West Culburra Subdivision Development
Transport and Accessibility Impact Assessment
Addendum Report

Issue: A 01/10/13

Client: Reality Realizations Pty Ltd

Reference: 12S1231000

Figure 3.1: Princes Highway/ Kalandar Street Intersection - potential layout

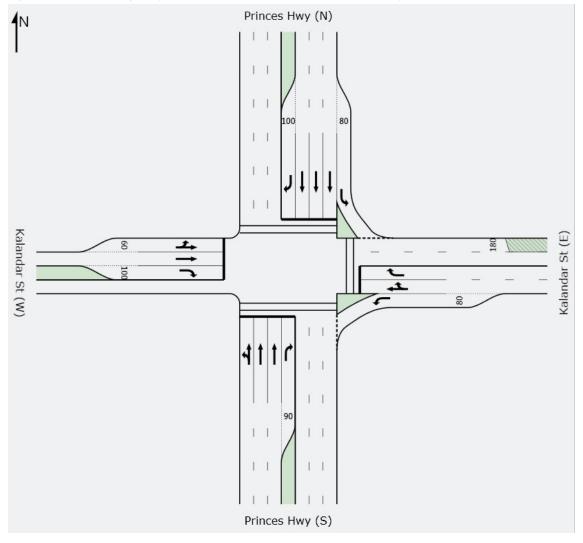
- The above analysis indicated that the subject development will likely have a very significant impact on the intersection of the Princes Highway and Kalandar Street. The proponent should identify suitable infrastructure required to ameliorate these impacts on the network as a result of the subject development. These should be submitted to the Department and forwarded to RMS for comment.

Given this, GTA Consultants undertook a desktop investigation to identify potential improvements to increase capacity at the intersection. Under existing 120<sup>th</sup> HH traffic volumes, the following improvements were identified and incorporated into the SIDRA model to provide a significant improvement in intersection Level of Service (LOS D or better):

- Kalandar Street (eastern approach) provision of an additional, dedicated left-turn slip lane
- **Kalandar Street (western approach)** provision of a dedicated right turn lane and an additional, dedicated through-lane
- **Princes Highway (northern and southern approaches)** removal of the concrete medians and provision of an additional through-lane in each direction

Significant improvements are therefore required at the intersection to reduce delays and provide a LOS D or better under existing 120<sup>th</sup> HH equivalent traffic volumes. The most critical improvement required is increasing the capacity of the Princes Highway to three lanes in each direction. This increase in capacity would be required beyond the intersection approaches to ensure there is sufficient upstream and downstream capacity.

Figure 5.2: Culburra Road/Collector Road - priority controlled intersection schematic layout

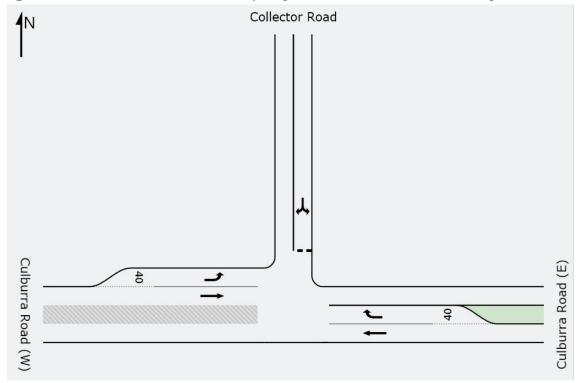
RMS does not support roundabouts within speed zones above 80km/hr. The proponent should determine an appropriate junction treatment at the intersection of the Princes Highway and the new collector road to allow safe access into and out of the development within the existing speed zone. In this regard, refer to Figure 4.9: Warrants for turn treatments on the major road at unsignalised intersections, in Austroads *Guide to Road Design - Part 4A: Unsignalised and Signalised Intersections*. RMS is unlikely to support a speed zone reduction at this location.

Based on the estimated traffic volumes, Figure 5.1 indicates that for an unsignalised intersection a channelised T-junction with a full length right-turn treatment on the major road (CHR) is warranted with either an auxiliary left-turn lane (AUL) treatment or channelised left-turn lane (CHL) on the major road.

Based on Table 7.1 and Table 8.2 of Austroads Guide to Road Design Part 4A and the existing 100km/hr speed zone on Culburra Road, the major road left and right turn lanes are required to be a minimum of 40m long with a 30m taper. There are no numerical warrants for the provision of acceleration lanes.

Figure 5.2 shows a schematic layout of a priority controlled intersection treatment at the Culburra Road/Collector Road (east) intersection with left and right turn lanes on Culburra Road.
